BROWNS FERRY NUCLEAR PLANT (BFN) – UNITS 1, 2, AND 3 – TECHNICAL SPECIFICATIONS (TS) CHANGES TS-418 AND TS-431 – EXTENDED POWER UPRATE (EPU) – RESPONSE TO ROUND 23 REQUEST FOR ADDITIONAL INFORMATION (RAI) REGARDING STEAM DRYER SIGNAL PROCESSING (TAC NOS. MD5262, MD5263, AND MD5264)

**TENNESSEE VALLEY AUTHORITY
BROWNS FERRY NUCLEAR PLANT (BFN)
UNITS 1, 2, AND 3**

**TECHNICAL SPECIFICATIONS (TS) CHANGES TS-431 AND TS-418
EXTENDED POWER UPRATE (EPU)**

**RESPONSE TO ROUND 23 REQUEST FOR ADDITIONAL INFORMATION (RAI)
REGARDING STEAM DRYER SIGNAL PROCESSING**

Figure EMC.B.203-1.14a: Cross spectra (top) and coherence (bottom) of notch filtered data for BFN1 main steam line A, for CLTP conditions (black) and LF conditions (blue).

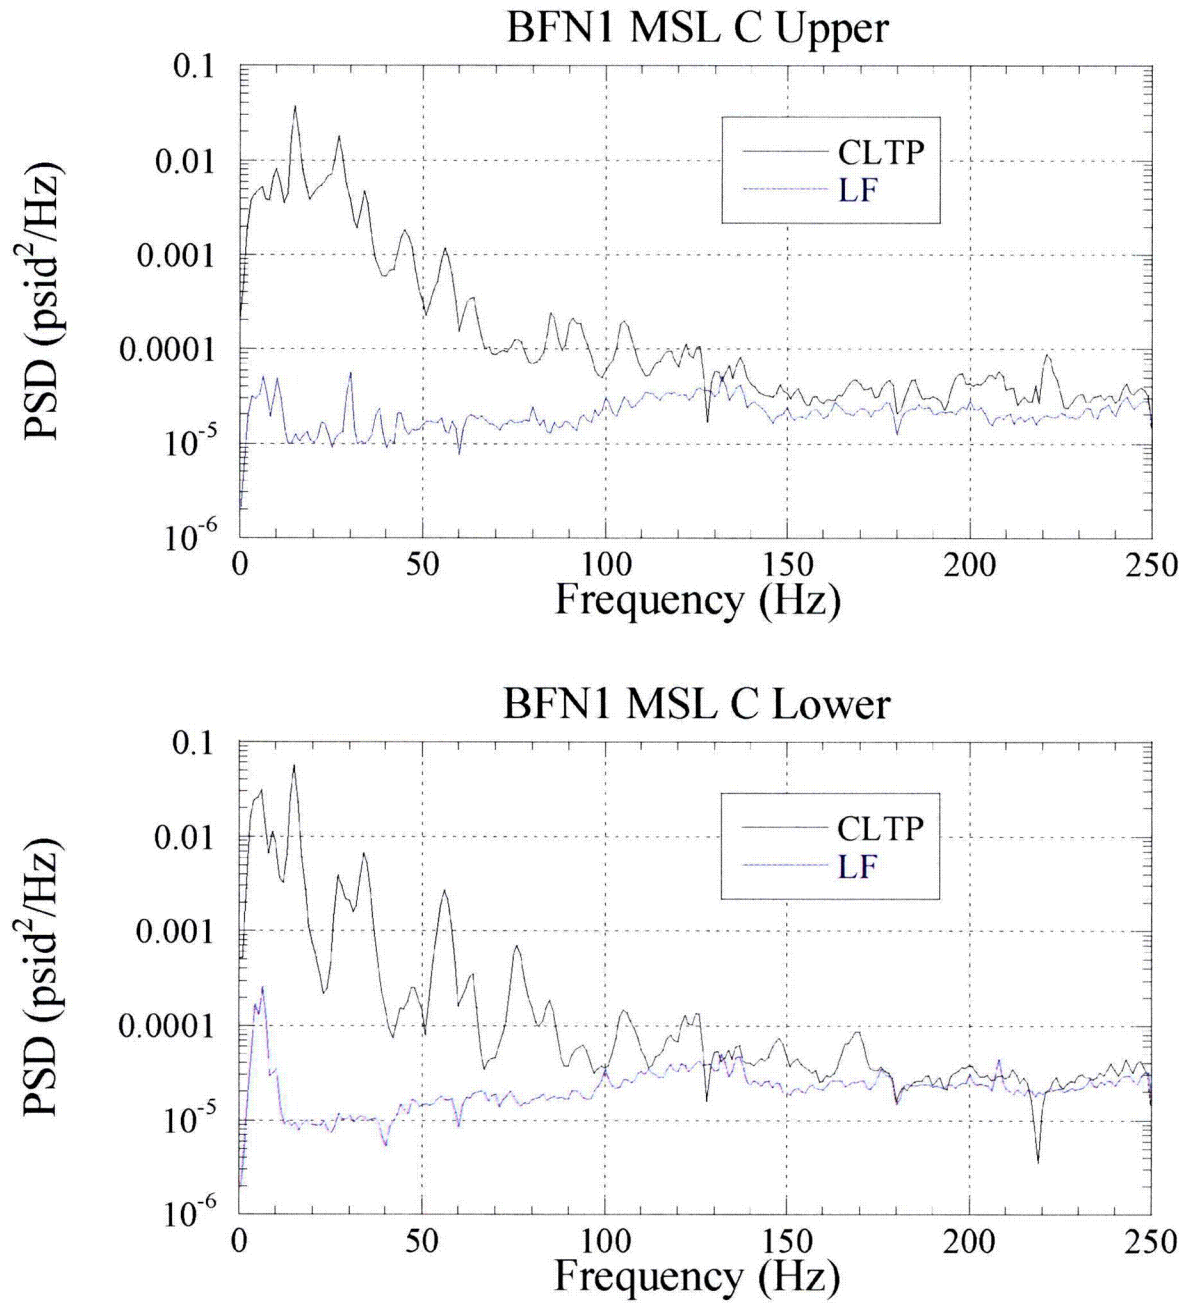
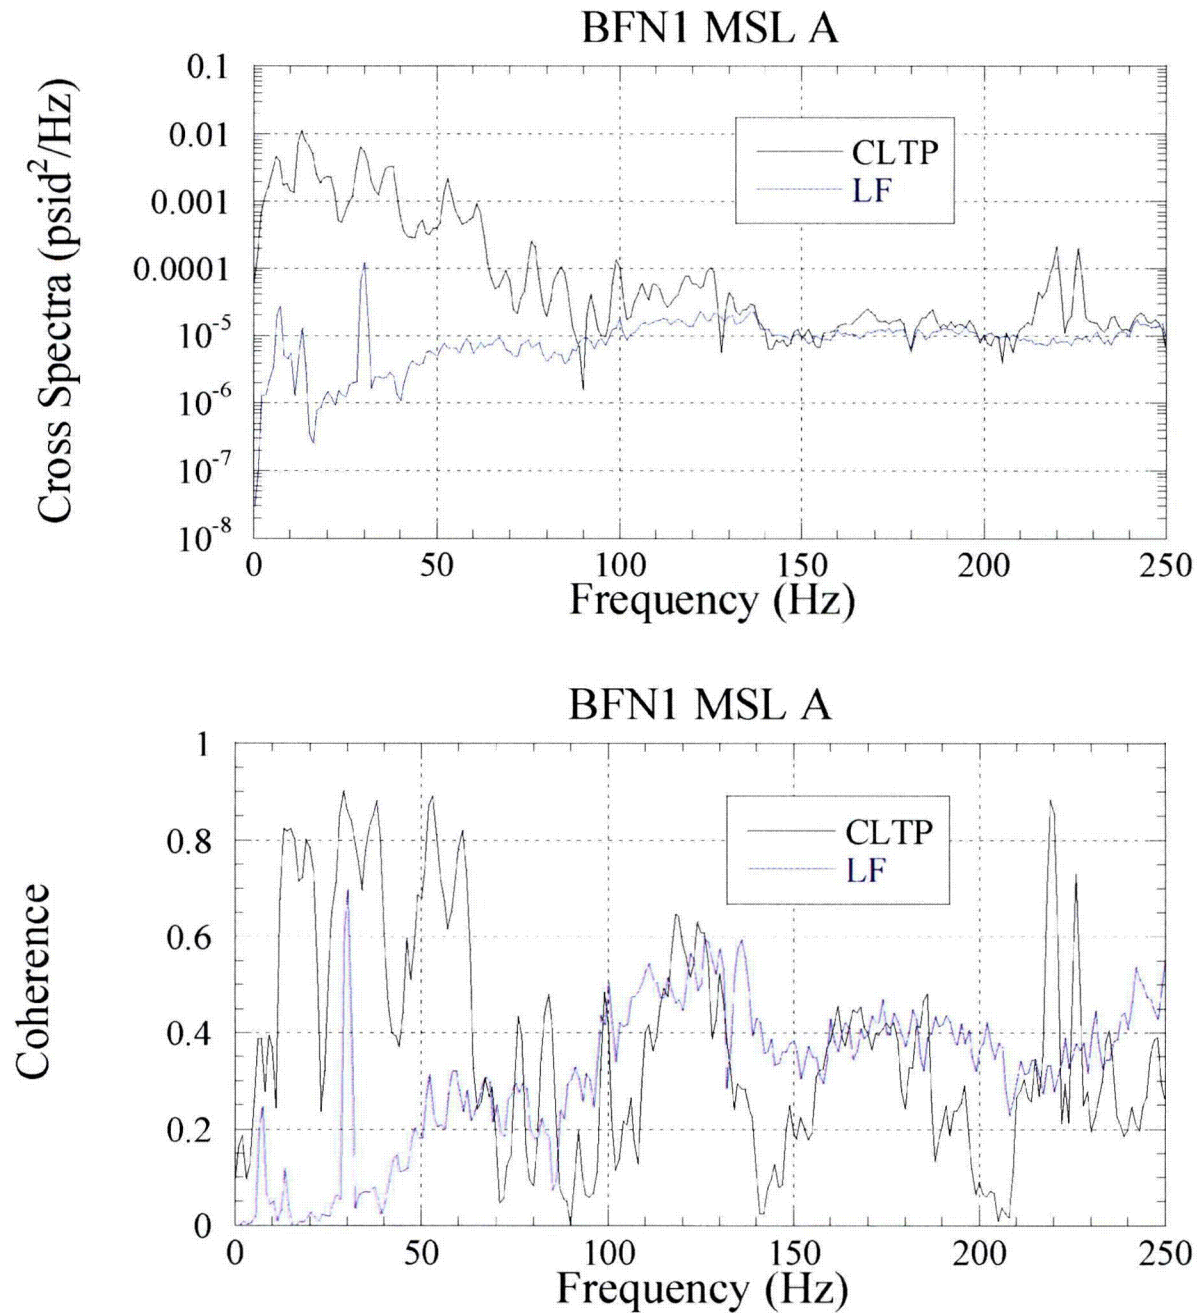
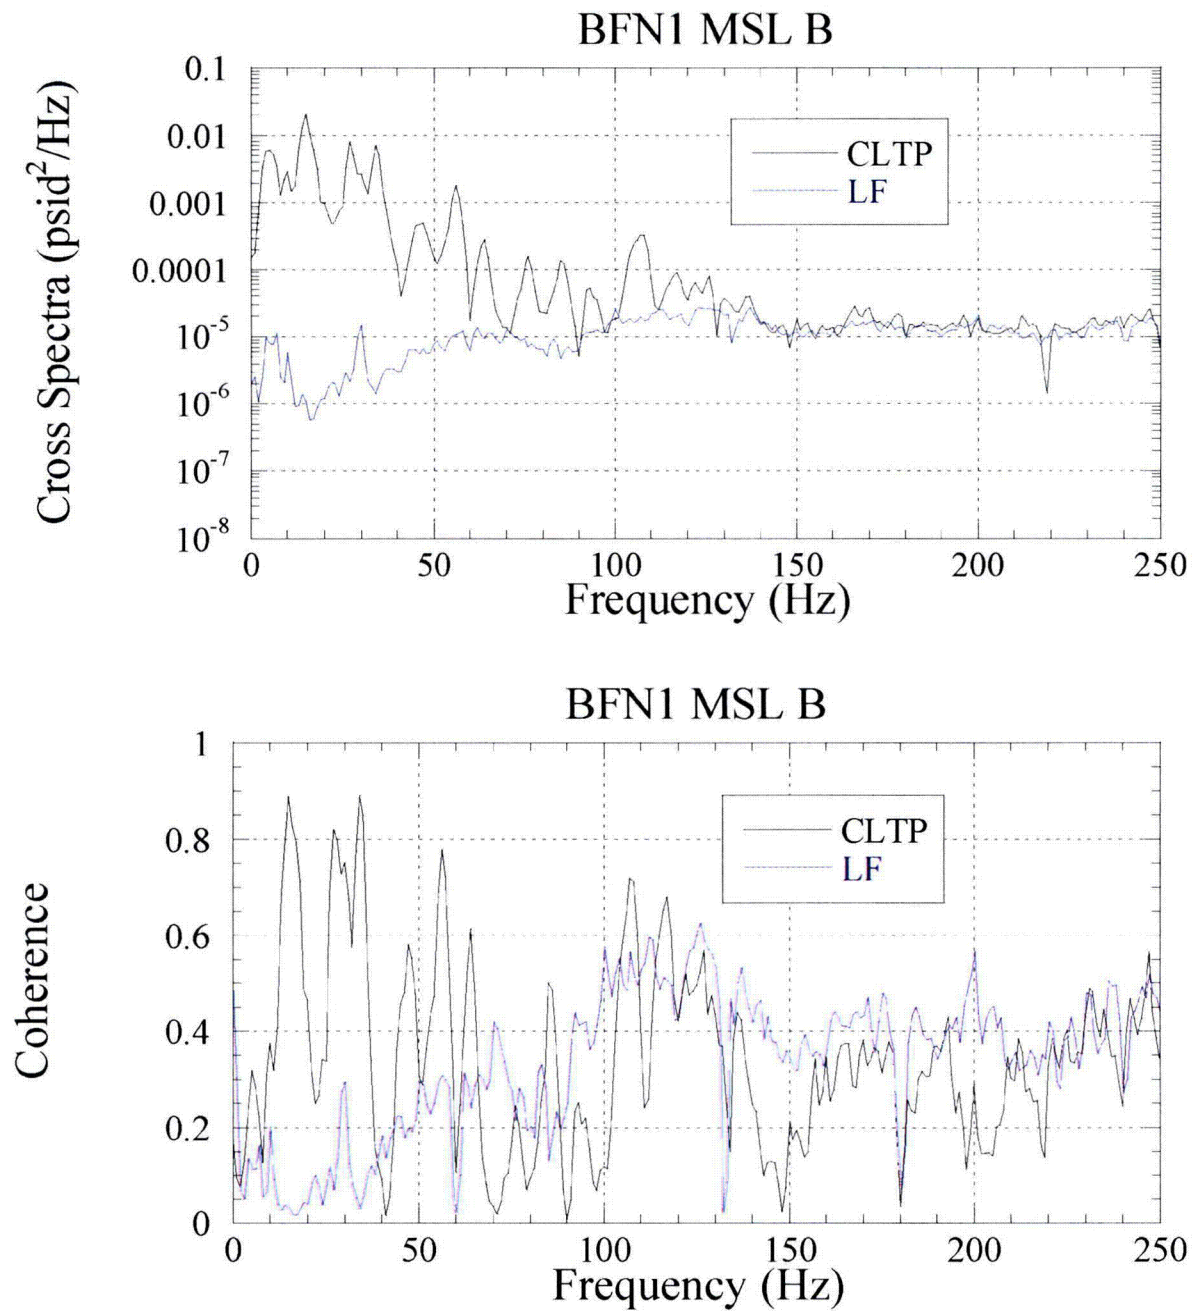
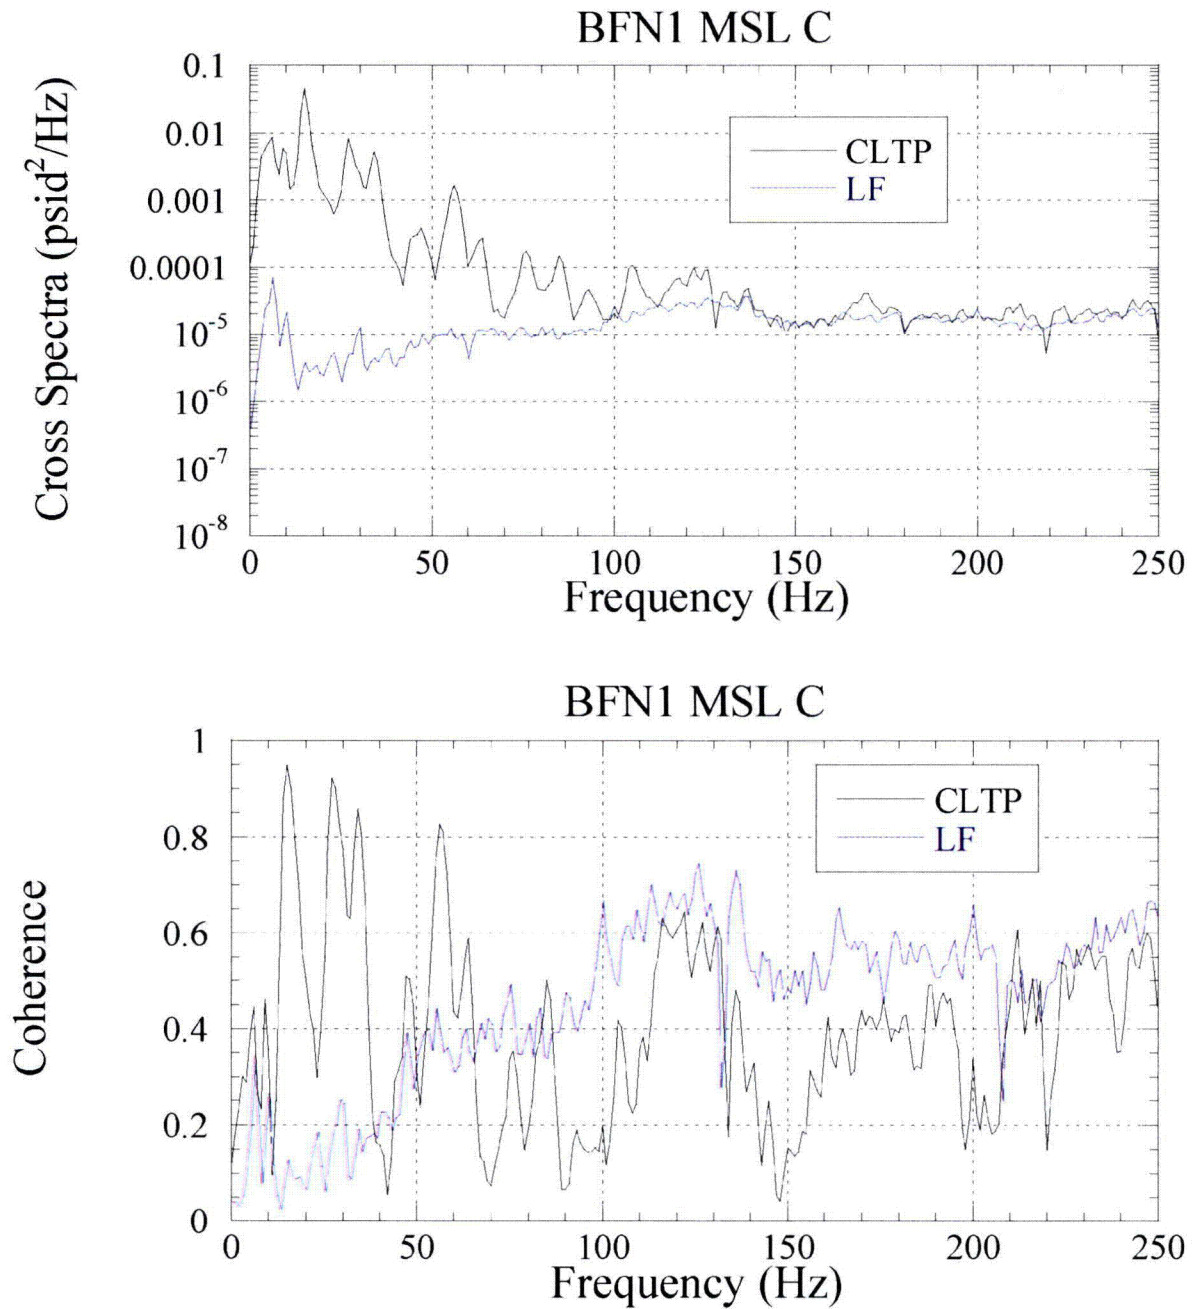
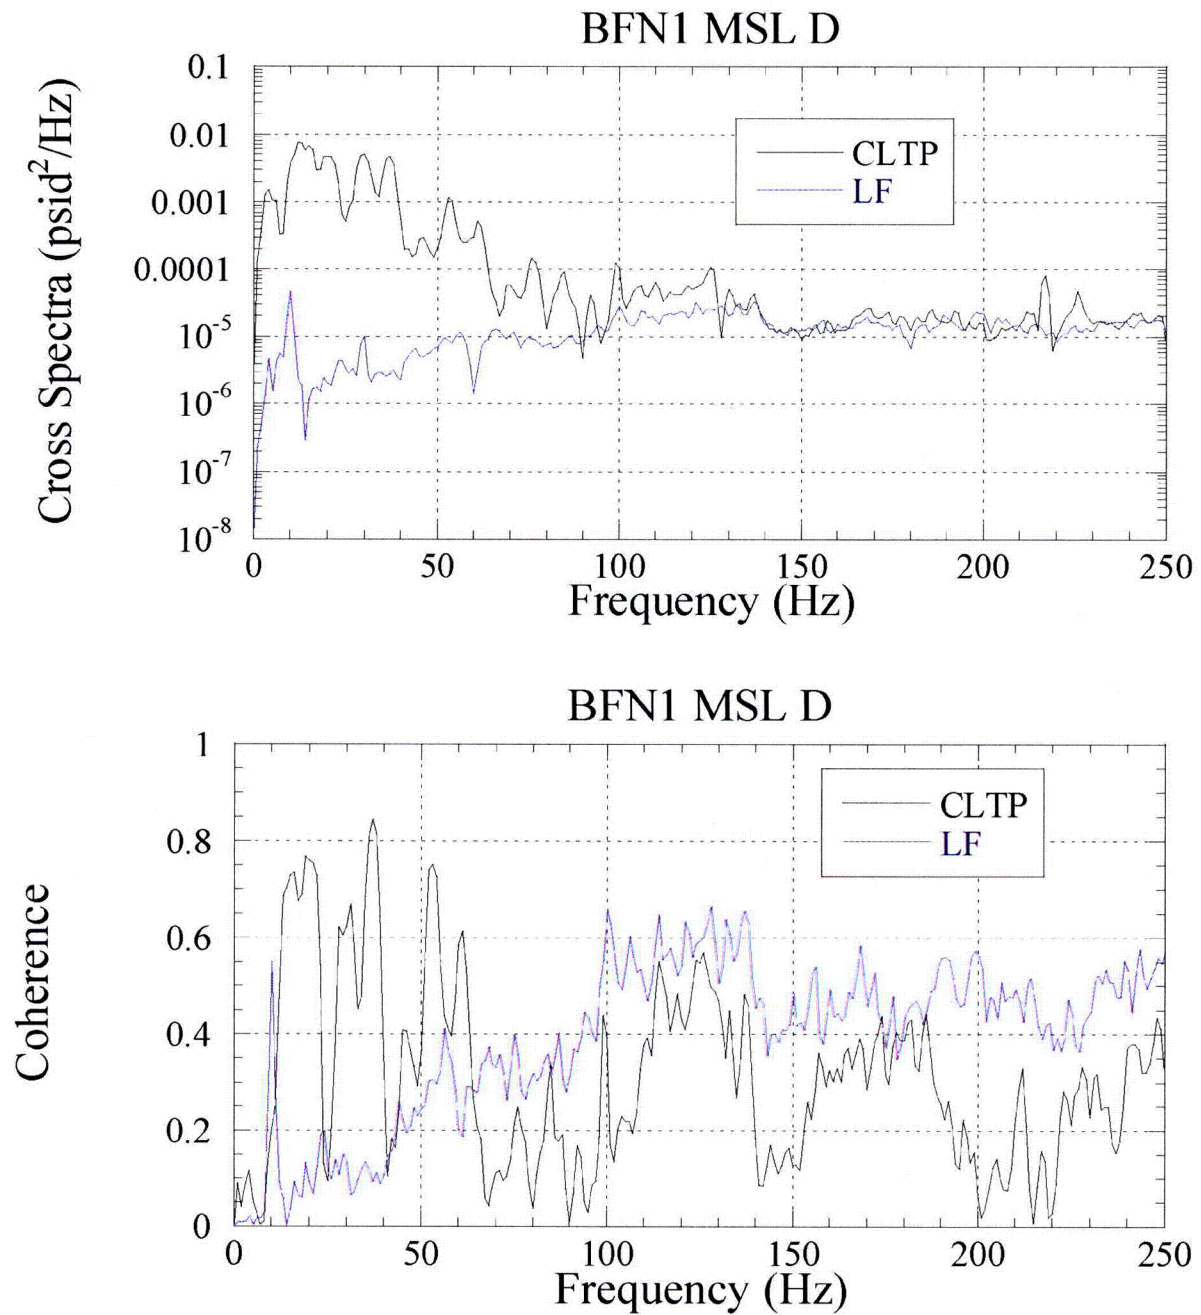
In response to EMCB.200/157., TVA presents detailed discussion of signal conditioning in six steps. Provide plots of strain gage signals (autospectra, cross spectra, coherence, and phase) and computed [[]] throughout the procedure described in their RAI response (prior to step 1, after step 1, after step 2, after step 4 and after step 6), for current license thermal power (CLTP) and Low Flow (LF) signals, for Units 1 and 2.

After Step 2: apply notch filters
